7.3.1 PROPOSED MIXED USE DEVELOPMENT WITHIN A 44 STOREY BUILDING - LOTS 2-20 NO. 74 MILL POINT ROAD, SOUTH PERTH.

Form 1 - Responsible Authority Report
(Regulation 17)

Property Location:	Lots 2-20 (No. 74) Mill Point Road, South Perth
Application Details:	Proposed Mixed Development within a 44 Storey Building, plus 3 basement levels
DAP Name:	Metro Central JDAP
Applicant:	Hillam Architects
Owner:	Edge Holdings Pty
LG Reference:	MI3/74 – 11.2016.2
Responsible Authority:	City of South Perth
Reporting Officer:	Erik Dybdahl, Planning Officer, City of South Perth
Authorising Officer:	Vicki Lummer, Director Development and Community Services, City of South Perth
Department of Planning File No:	DAP/16/00974
Report Date:	11 April 2016
Application Receipt Date:	30 December 2015
Application Process Days:	106 Days
Attachment(s):	<ol style="list-style-type: none"> 1. Amended Development Application Report (Latest Revision 23rd March 2016). 2. Amended Development Floor Plans: A2-01 through A2-17 (Latest Revisions 16th March 2016). 3. Amended Development Elevation Plans: A3-01 through A3-04 (Latest Revisions 16th March 2016). 4. Perspective Drawing. 5. Plot Ratio and Car Parking Summary. 6. Su

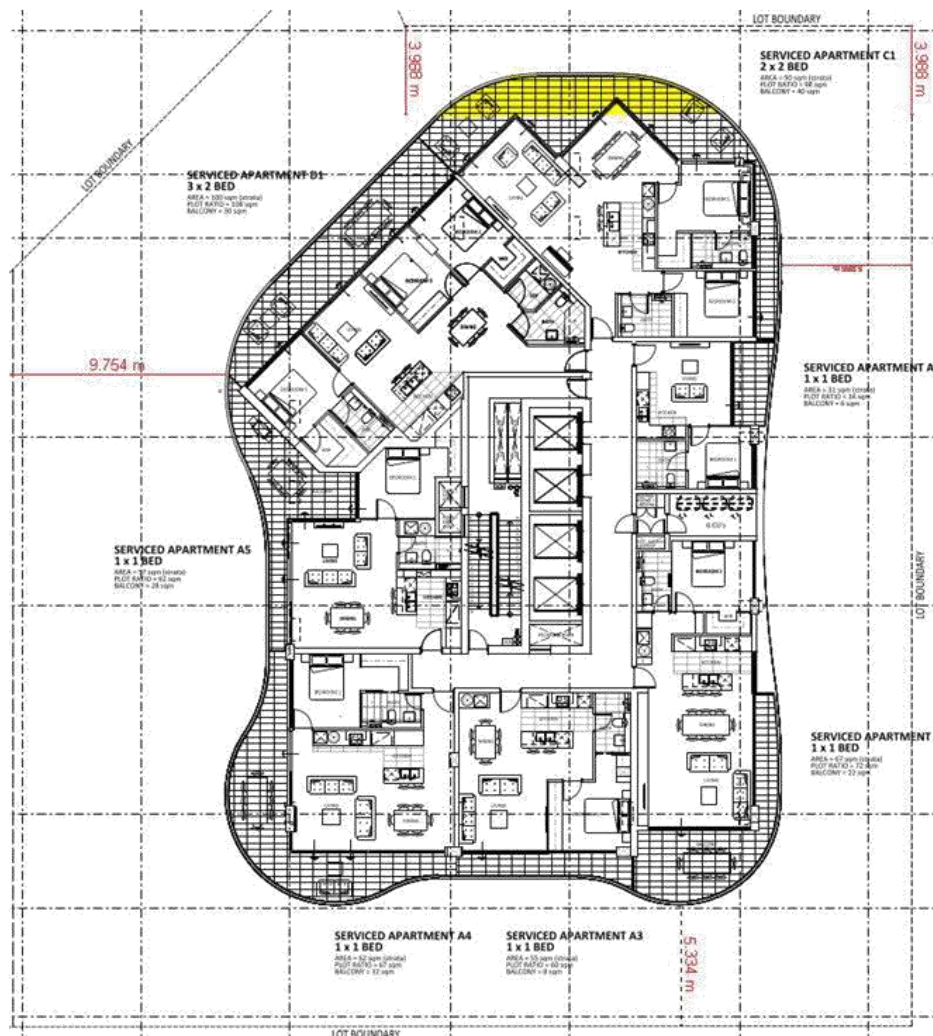
- (i) The nil podium street setback is seen to be inconsistent with proposed Schedule 9A Element 7 Development Requirements. Should this application be approved, it could impair podium setbacks being required Mill Point Road.

- (ii) The proposed change to the permitted podium street setback impacts this application. Whether this element of the Amendment is seen to be consistent with sound town planning principles is unclear, as in responding to streetscape and visual impact concerns, the Amendment could be seen to conflict with the pedestrian amenity and active street frontage objectives for the precinct. The relevant Guidance Statement in the Amendment lists the potential reasons for the increased street setback being related to the larger street setbacks of existing buildings (approved prior to the creation of the Special Control Area) in the same street, a narrow street and/or significant street trees. As discussed above, the street trees are considered to be adequately protected. The gazettal of a change to the required podium street setback is uncertain, as the Council has not yet considered submissions at the time of RAR preparation and the WAPC recommendation and Minister's final decision is unknown. The gazettal of Amendment No. 46 is not imminent, as its final approval is months away.

Diagram 3.4
Current development application
Overshadowing at 12pm June 21st.

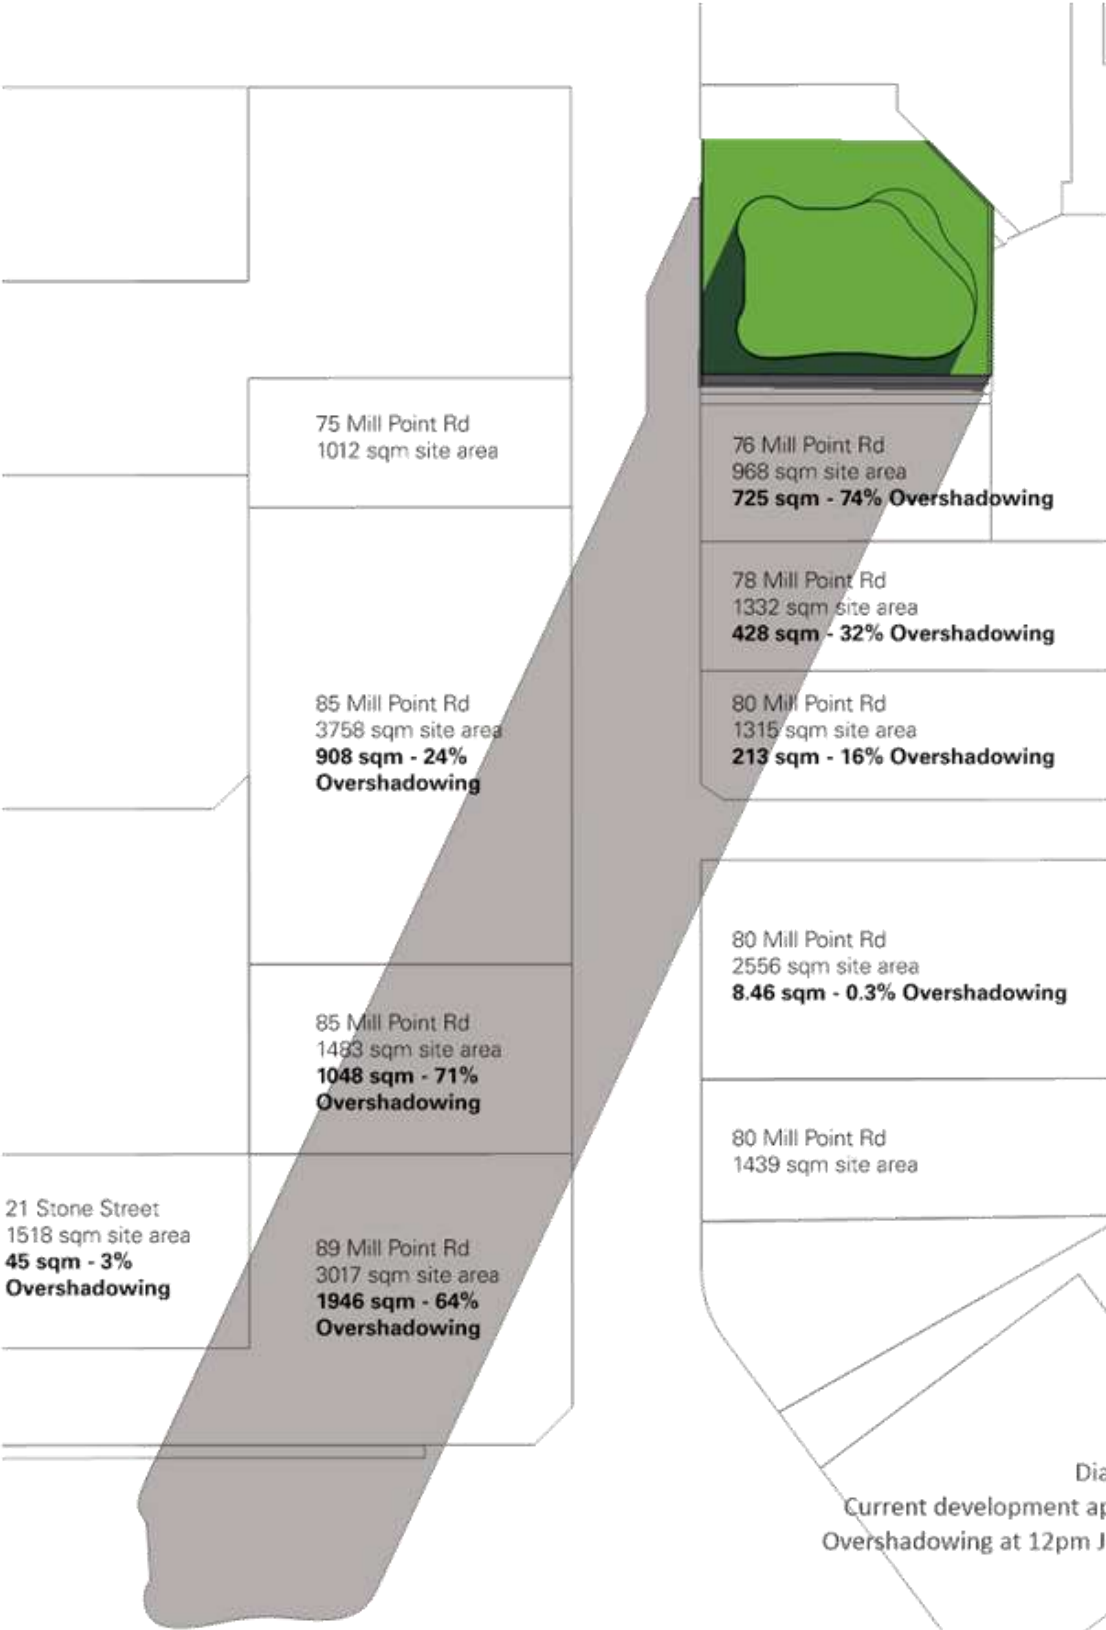
by Council.	<p><i>Proposed Amendment No. 46 expands this criterion, listing points to consider in arriving at an opinion. The City notes the following:</i></p> <ul style="list-style-type: none"> <i>(a) The podium façade is seen to provide a high quality presentation, dominated by a Café/Restaurant tenancy open during daytime and night time hours.</i> <i>(b) The visual presentation of the tower is seen to pose a positive contribution to the locality.</i> <i>(c) The materials and finishes identified on the submitted drawings are seen to make a beneficial contribution to the overall design quality.</i> <p><i>The design of the proposed tower is considered to meet this criterion with the exception of the overall height of the building, to be discussed further below.</i></p> <p>Criterion Satisfied</p>
<p>Overshadowing – The proposed development has been designed with regard for solar access for neighbouring properties taking into account ground floor outdoor living areas, major openings to habitable rooms, solar collectors and balconies.</p>	<p>The applicant has supplied an overshadowing diagram, based upon 12 noon on 21 June (winter solstice). At this time, the shadow is cast over parts of nearby residential and commercial buildings on Mill Point Road. The most impacted site is that immediately adjoining the development site at 76-78 Mill Point Road. The City is currently considering an application for approval at 76-78 Mill Point Road of a similar proposal to the subject site. (See Attachment 10 overshadowing diagrams)</p> <p><i>The equivalent provision in Proposed Amendment No. 46 restricts the portion of the building above the Building Height Limit, to overshadowing an adjoining property by up to 80 per cent of its site area. The current proposal is compliant with this proposed provision, as the additional height does not result in the additional shadow cast causing more than 80% overshadowing overall.</i></p> <p><i>None of the affected properties are overshadowed by 80% by the forecast shadow at 12:00PM on June 21st (Attachment 10)</i></p> <p>Criterion Satisfied</p>
